Current loop interface v1.2

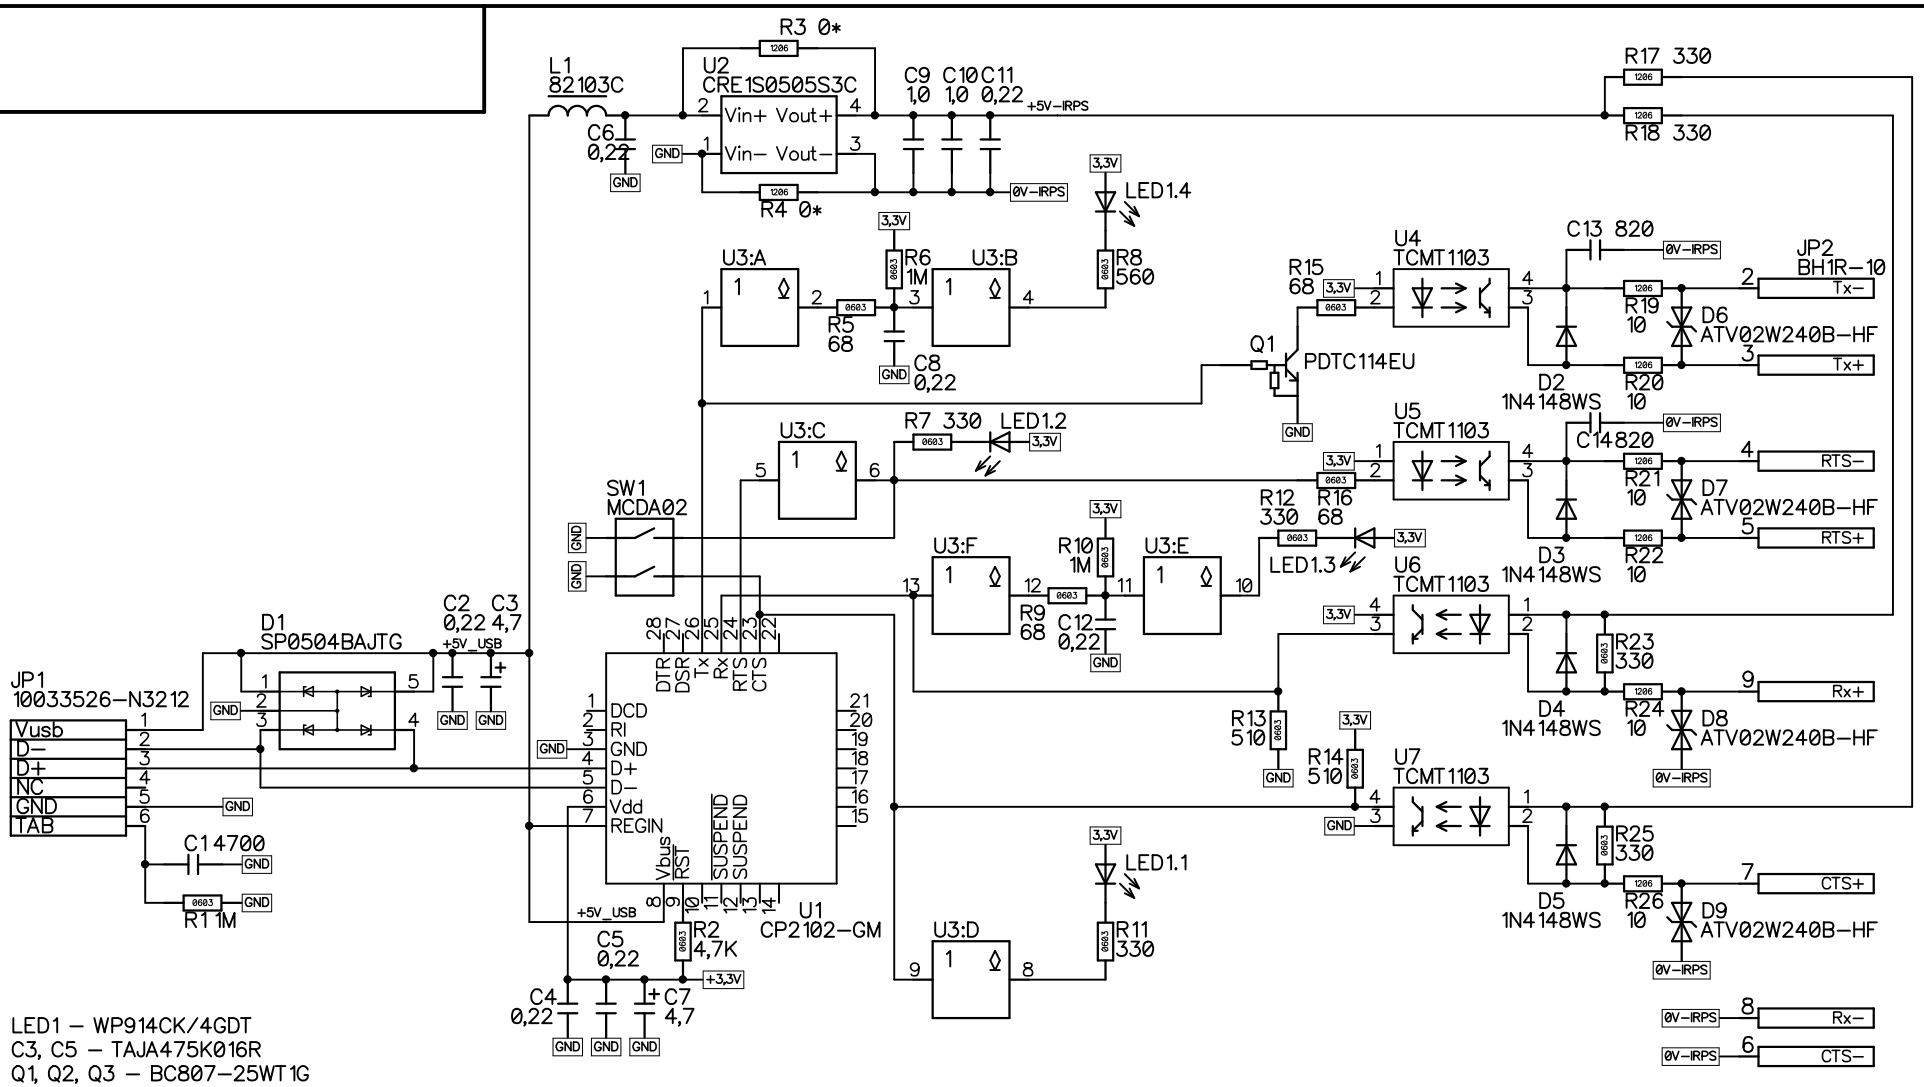
LED1 – WP914CK/4GDT
C3, C5 – TAJA475K016R
Q1, Q2, Q3 – BC807–25WT1G
U3 – SN74LVC07APW
C2,4,5,8,12 should be the same capacitance
